ITEM E5 – FORT RAYMOND SUBDIVISION REPLAT NUMBER 5

KPB File No.	2022-029
Plat Committee Meeting:	April 11, 2022
Applicant / Owner:	City of Seward, Alaska
Surveyor:	Stacy Wessel / AK Lands Land Surveying
General Location:	Sea Lion Avenue, City of Seward

STAFF REPORT

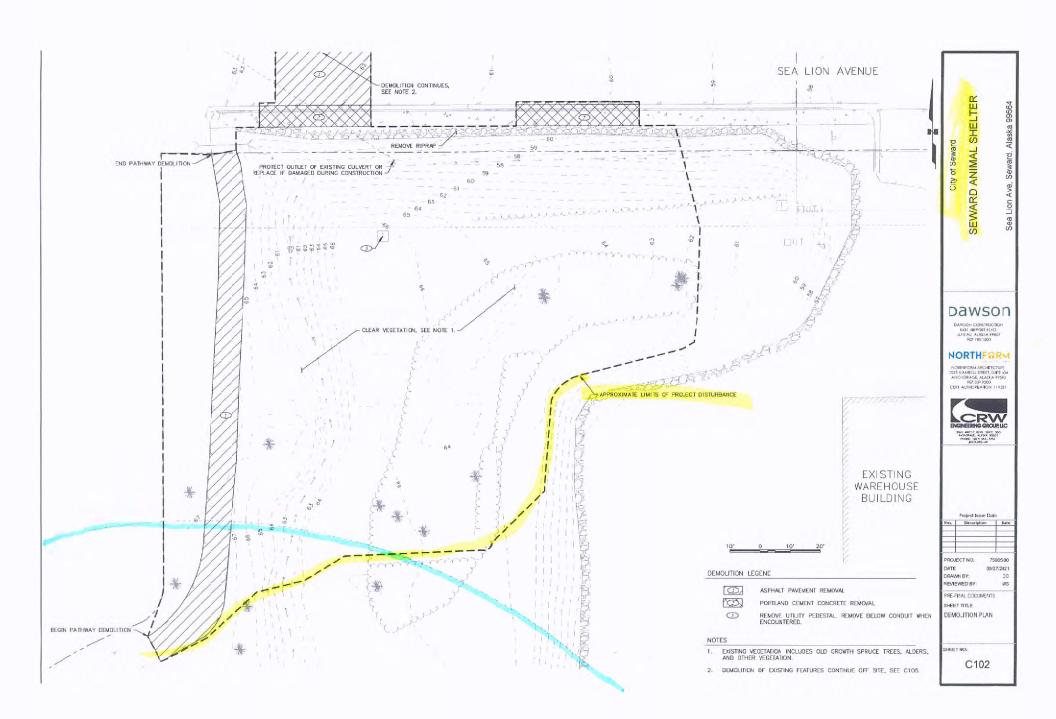
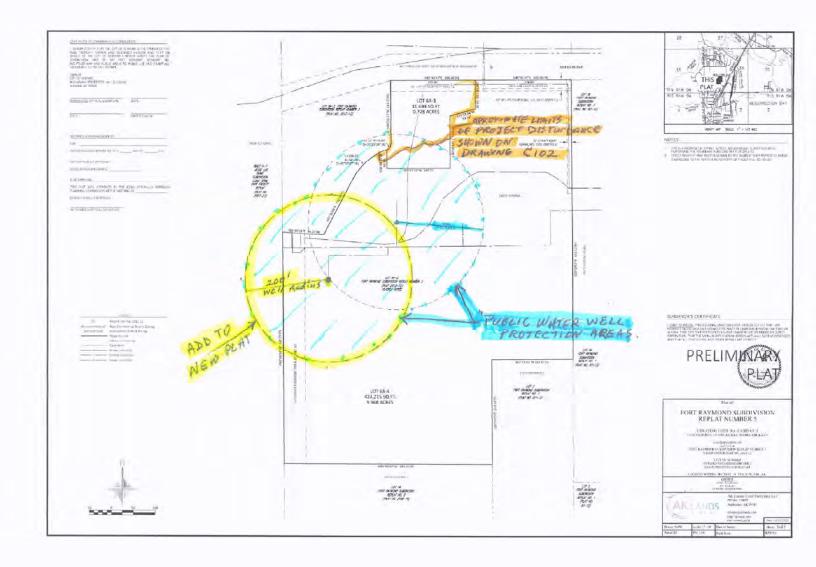
e receiving a hard copy of this memo. Please print your comments clearly—I have aff review in a word document if you would prefer to type your comments in.
signed copy v	be heard before Planning and Zoning on March 1st, 2021. <u>Please review and return a with comments of the attached memo by Thursday, February 18, 2022</u> so that your new included in the staff report.
☐ I Have No	Comments
comments:	nments On this Case (attach eet if needed) If still have concerns of the new animal of property Line moving further south into ublic water well Protection Area". The ublic water well Protection Area". The ed project Limits were further north, see attached of the protection area of the this new plat.
added	see attached 2 drawings
